SUBJECT: Recommended Changes to be Incorporated in Revision 4 of the Standard  
Technical Specifications, NUREG-1430 through 1434

## **TSTF Travelers Recommended to be Incorporated into Revision 4 of the Improved Standard Technical Specifications**

## Technical Specification Task Force Improved Standard Technical Specifications Change Traveler

### Correct Bases Discussion of Figure B3.0-1

[ Figure B 3.0-1  
Configuration of Trains and Systems ]

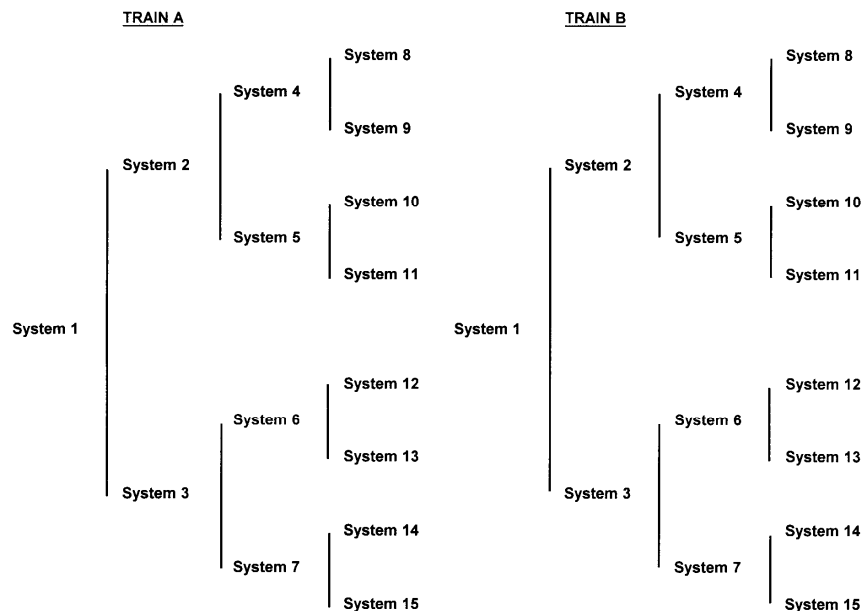
This Traveler revises the Examples that discuss Figure B 3.0-1 in the Bases of LCO 3.0.6 to more accurately describe a loss of safety function and to be internally consistent.

Examining Figure B 3.0-1, it is clear that if there is a loss of safety function in System 5, there is also a loss of safety function in the systems supported by System 5, Systems 10 and 11. This relationship is explicitly listed in Example B 3.0.6-3 and to not do so here is inconsistent and confusing as it leads the reader to believe that Systems 10 and 11 do not have a loss of safety function.

The phrase "which in turn is supported by System 5" is confusing. System 5 is not inoperable and does not lead to the loss of safety function. Examples B 3.0.6-1 and B 3.0.6-3 do not discuss OPERABLE support systems. This phrase adds no value and leads the reader to believe there is some special relationship with System 5 which does not exist.

If System 2 of Train A is inoperable and System 5 of Train B is inoperable, a loss of safety function exists in ~~supported~~ Systems 5, 10, and 11.

If System 2 of Train A is inoperable, and System 11 of Train B is inoperable, a loss of safety function exists in System 11 ~~which is in turn supported by System 5.~~
